Planning Commission Staff Report

Project Type: Amended Architectural Elevations

Description: **Larry Enterprises – Lynch Hummer, Lot B (Scott Retail):** Amended Architectural Elevations and an Amended Architect's Statement of Design for a 7.09 acre lot of land zoned "PI" Planned Industrial District located on the west side of Boone's Crossing on the north side of North Outer 40 Road.

Scott Retail Approved Elevation

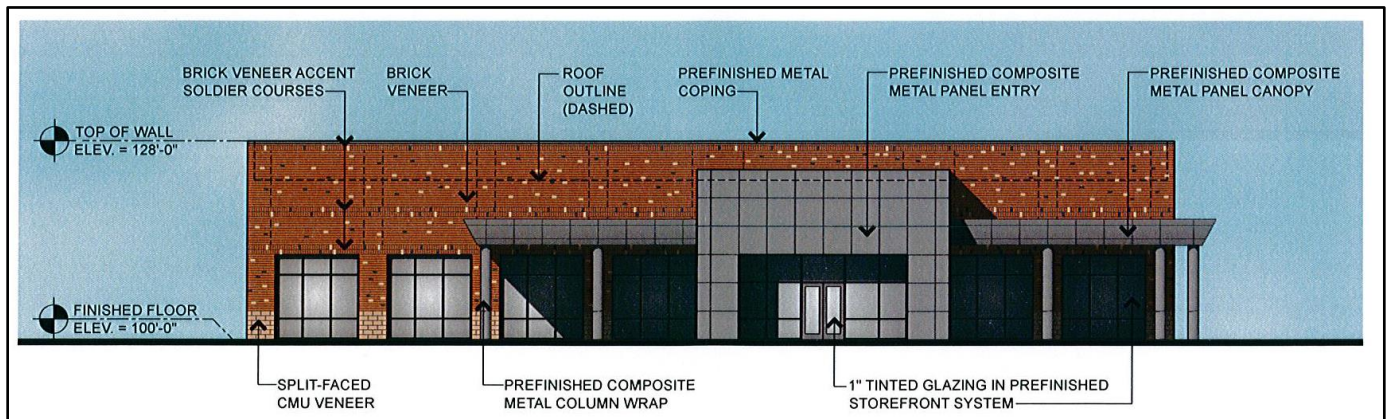
As shown above, the approved brick from the original elevation was a solid, red brick. The brick in the proposed elevation, which was used on the actual building, is predominately red in color, with lighter and darker accent bricks. The approved Architect's Statement of Design includes the following statement:

**PROPOSED AMENDED
ARCHITECTURAL
ELEVATION**

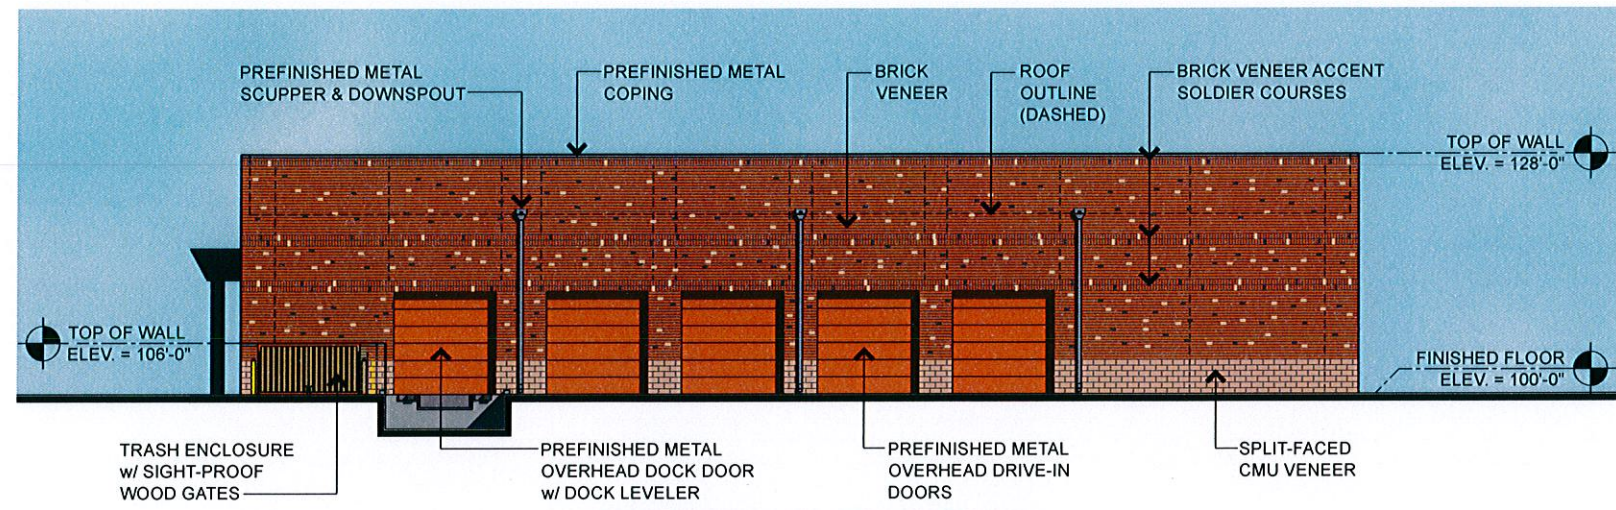
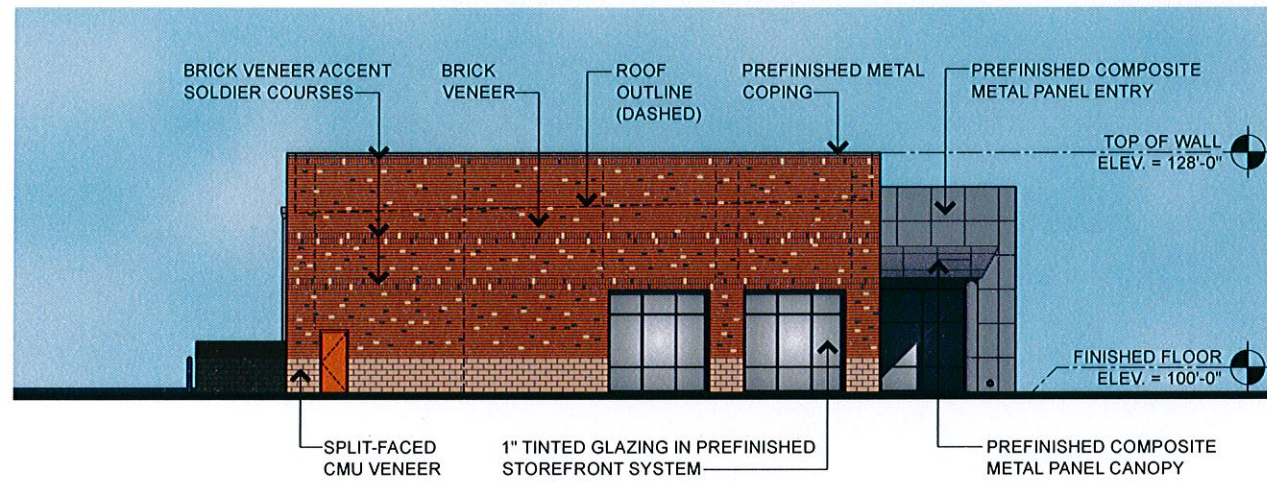
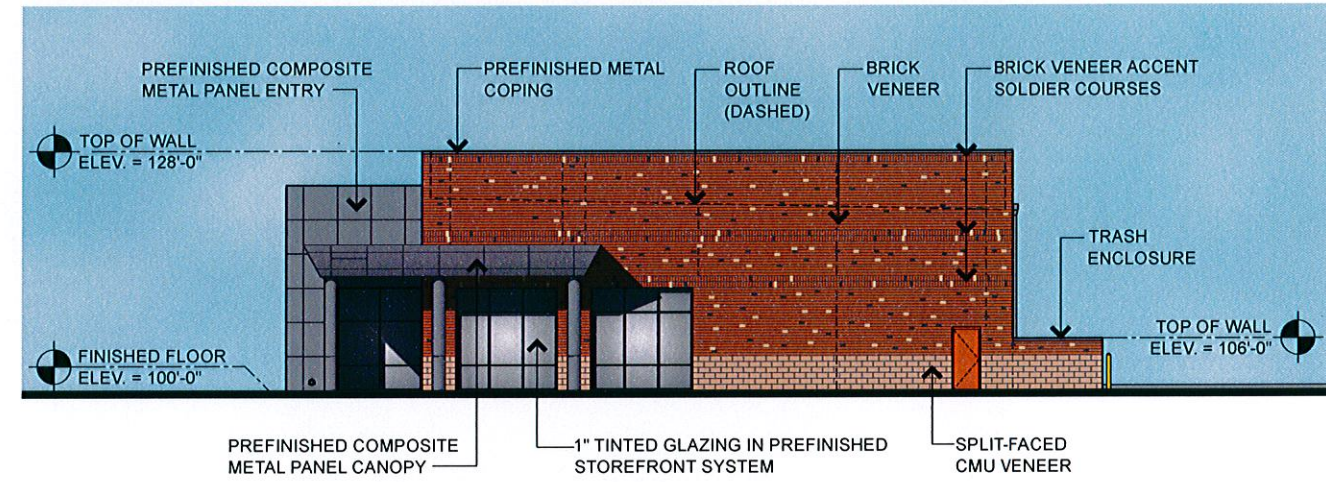
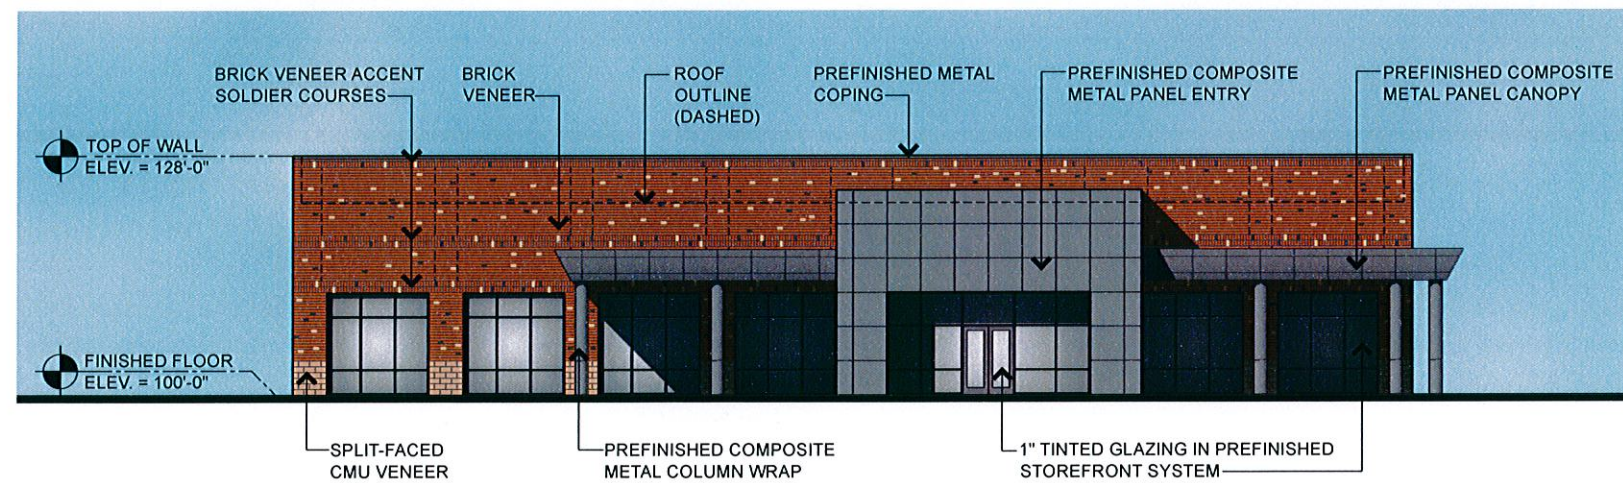
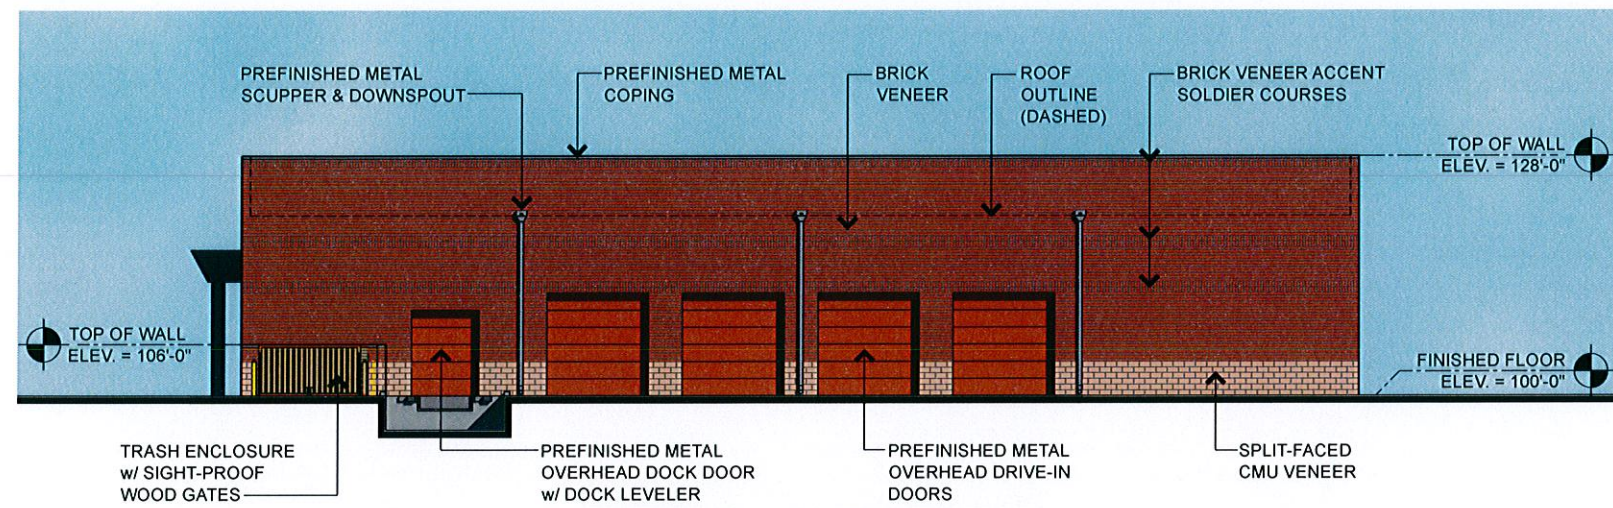
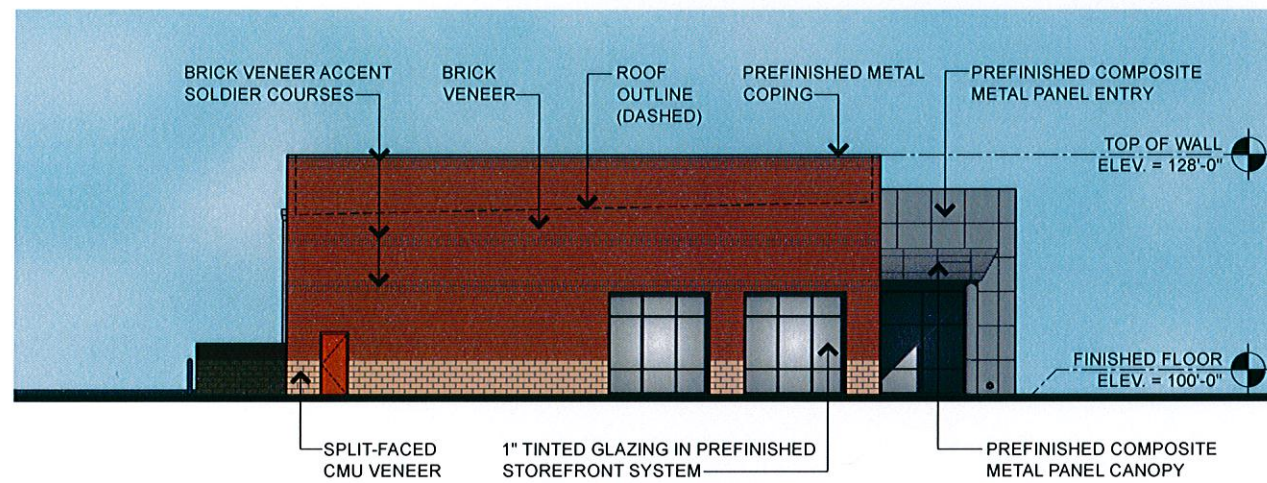
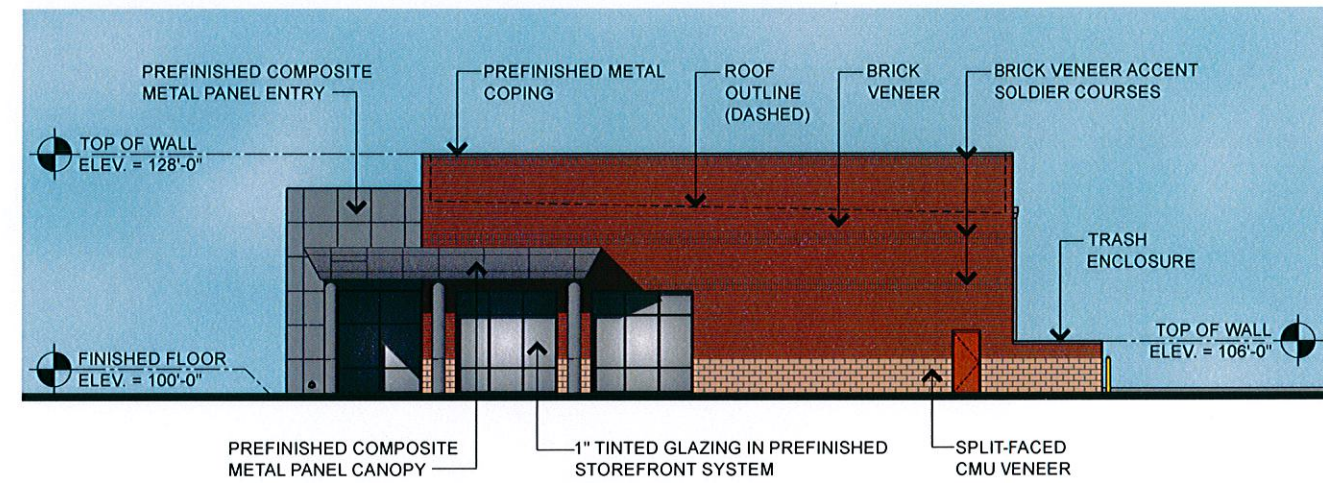
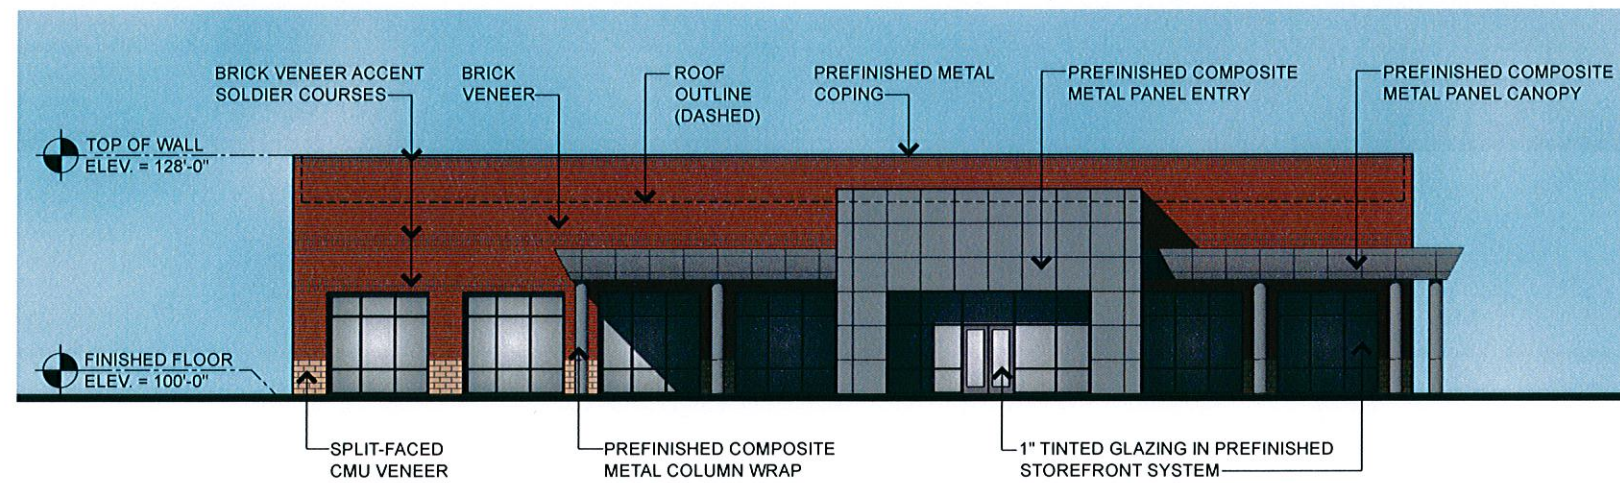
In addition to the change in the brick used, there is one other deviation from the approved architectural elevations. On the rear elevation, the approved architectural elevation shows four drive-in overhead doors and one smaller dock door with a leveler. On the actual building and included in the proposed revised architectural elevation, all five overhead doors are the same size.

EXTERIOR ELEVATIONS REVISED
& RESUBMITTED TO REFLECT
BRICK VENEER CHANGE AS
SELECTED BY THE OWNER
